As the owner of number  have the following objections regarding the proposed amendments to The Grove Plot 1, Billett Avenue.

ENGINEERING ASSESSMENT
BILLETT AVENUE

Figure 2 - Billett Avenue Topology Map (units=m)

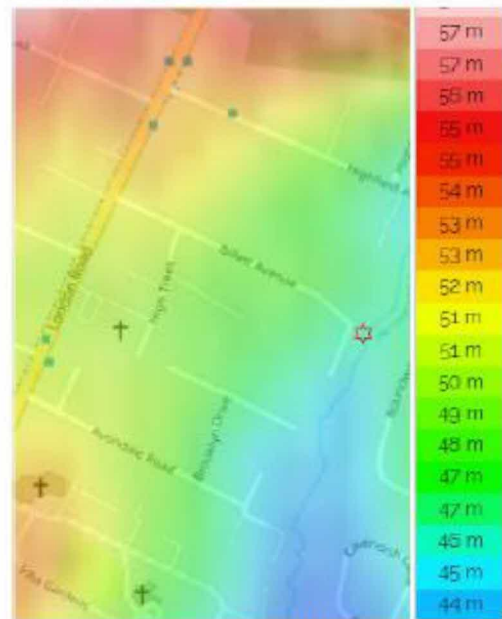
In addition to this a topology map (Figure 2) is used to determine the applicable road surface area that will contribute to flooding. Surface water will run from high to low areas with the greatest flow associated with the greatest gradient.

As shown there is a continued gradient from the entrance to Billett avenue all the way to the bottom.

[3] Site Plan (with proposed additional screening)

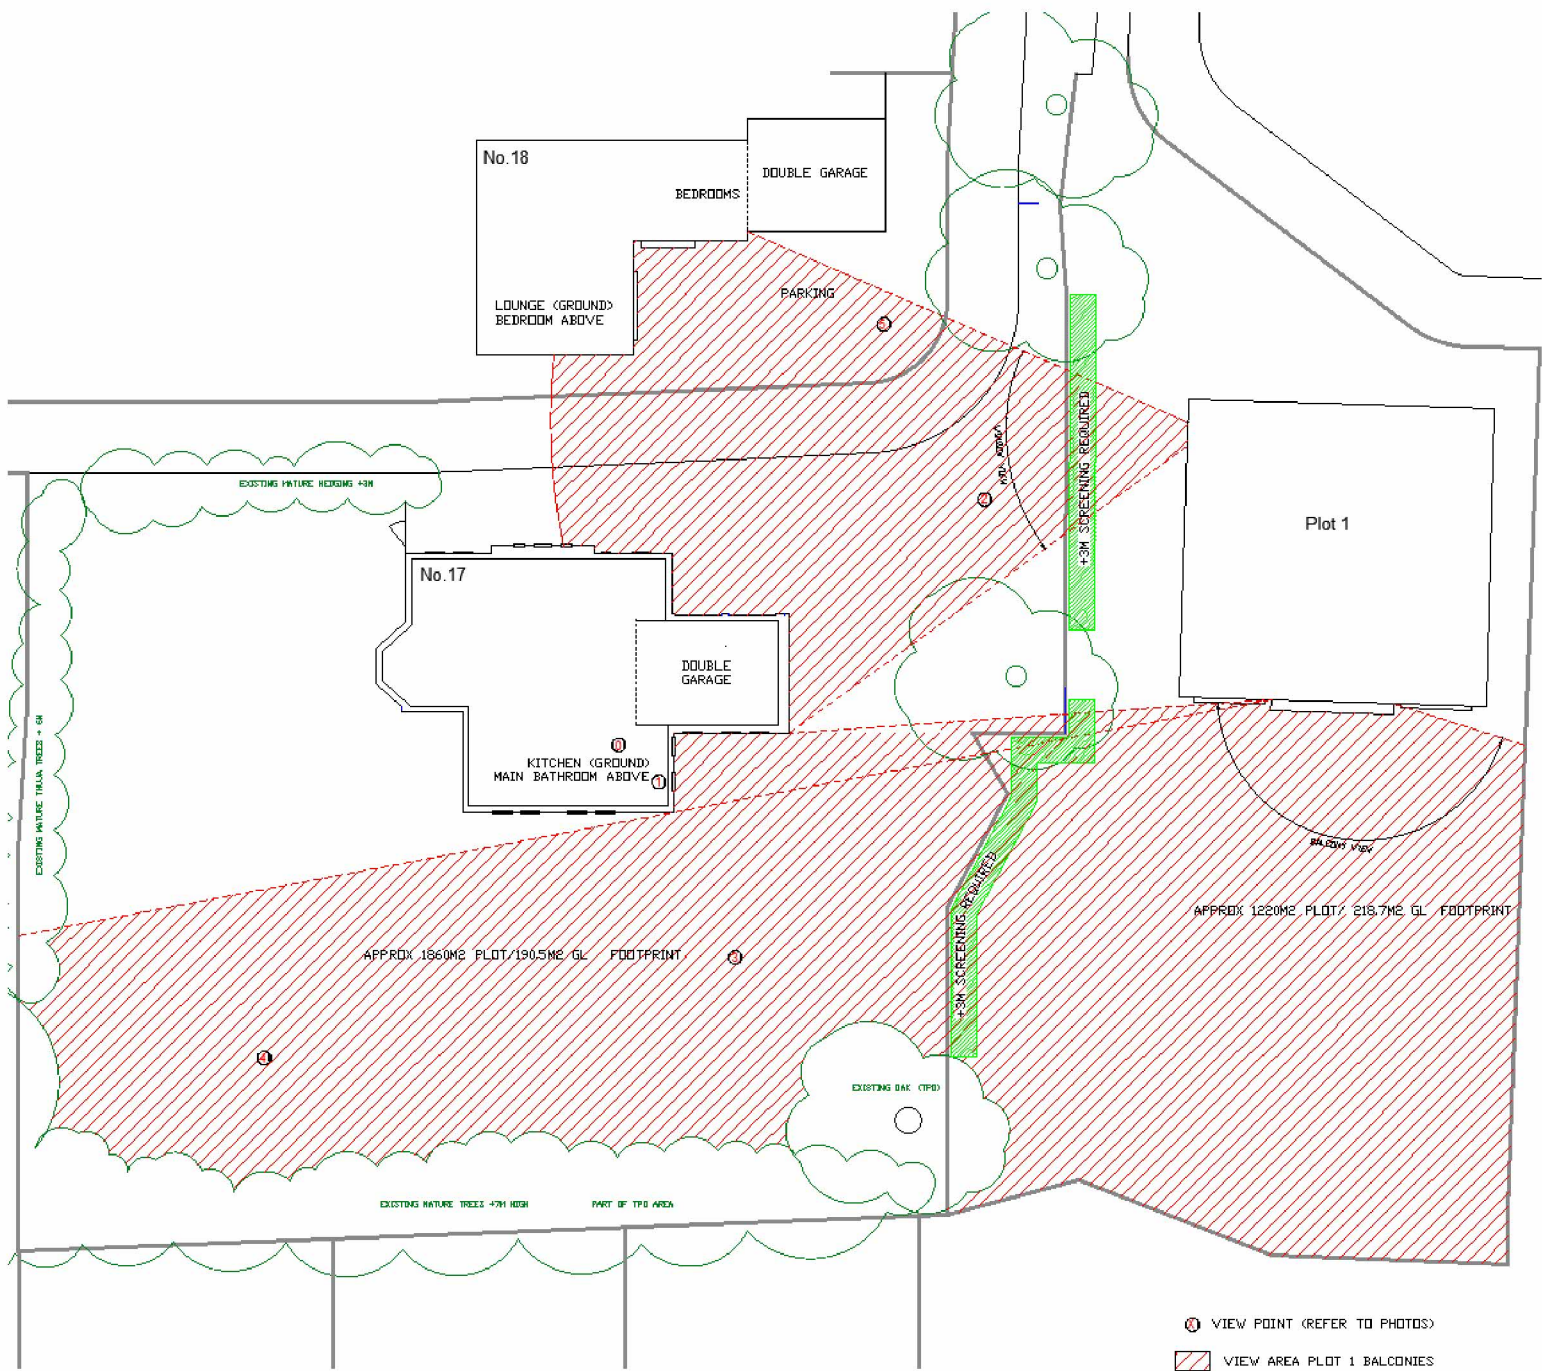
While adequate screening has been included for 15 Billett Avenue, sufficient screening should be deployed to maintain the avenues aesthetics for all properties. See [3] for additional screening proposal for No.17. There was existing hedging on Viewpoint 2, however this has died, we have been advised that this is due to the plot 1 site waste pile draining directly to the hedge. We are taking legal advice as to our rights for compensation to repair the hedge. However, we have been advised that due to existing driveway proximity, this will be the most costly option and therefore recommend that the plans are updated to include the screening proposed.
